Access Compliance Report

Public Rights-of-Way

(Curb Ramps)

Intersection ID: 4530	Main Street: BROOKSHIRE_BV	Cross Street: MT_HOLLY-HUNTERSVILLE_RD	Location:	N
ADA ID: BF5C7A821308	Ramp Type: Perp	Initial Pass/Fail: Fail	Overall Compliance: No	Severity Score: 8.75
Codes/Mitigation Info/Possible Solution		Field Measurements/Component Compliance

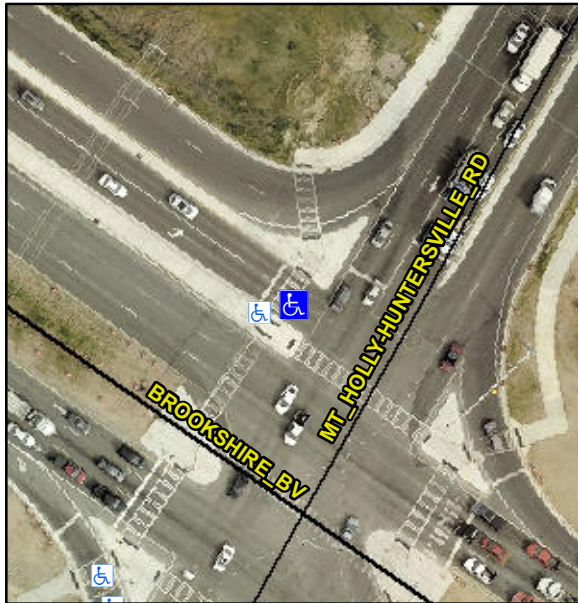
Compliance	Description	Data	Compliance	Description	Data
N/A	Ramp Length (in)	116.0	Yes	Ramp Slope (%)	5.5
No	Ramp Width (in)	45.0	Yes	Ramp XSlope (%)	0.4
N/A	Flare Type LT	N/A	N/A	Flare Type RT	N/A
N/A	Flare Slope LT (%)	N/A	N/A	Flare Slope RT (%)	N/A
N/A	Flare Traversable LT?	N/A	N/A	Flare Traversable RT?	N/A
N/A	Landing Length (in)	N/A	N/A	DWS Provided?	N/A
N/A	Landing Width (in)	N/A	N/A	DWS Contrast?	N/A
N/A	Landing Slope (%)	N/A	N/A	DWS Length (in)	N/A
N/A	Landing X Slope (%)	N/A	N/A	DWS Full Width?	N/A
N/A	Landing Curb? (Y/N)	N/A	N/A	DWS Offset (in)	N/A
N/A	Shared Landing?	N/A			
N/A	Gutter Ponding?	N/A	N/A	Gutter Slope (%)	N/A
N/A	Gutter Lip Ht (in)	N/A	N/A	Gutter X Slope (%)	N/A
N/A	Painted X Walk1?	No	N/A	Painted X Walk2?	N/A
	X Walk 1 Direction	To SE		X Walk 2 Direction	N/A
N/A	X Walk 1 Width (in)	N/A	N/A	X Walk 2 Width (in)	N/A
	X Walk 1 Slope (%)	0.2		X Walk 2 Slope (%)	N/A
	X Walk 1 X Slope (%)	7.2		X Walk 2 X Slope (%)	N/A

Remove & Replace Entire Ramp.

R304.5.1
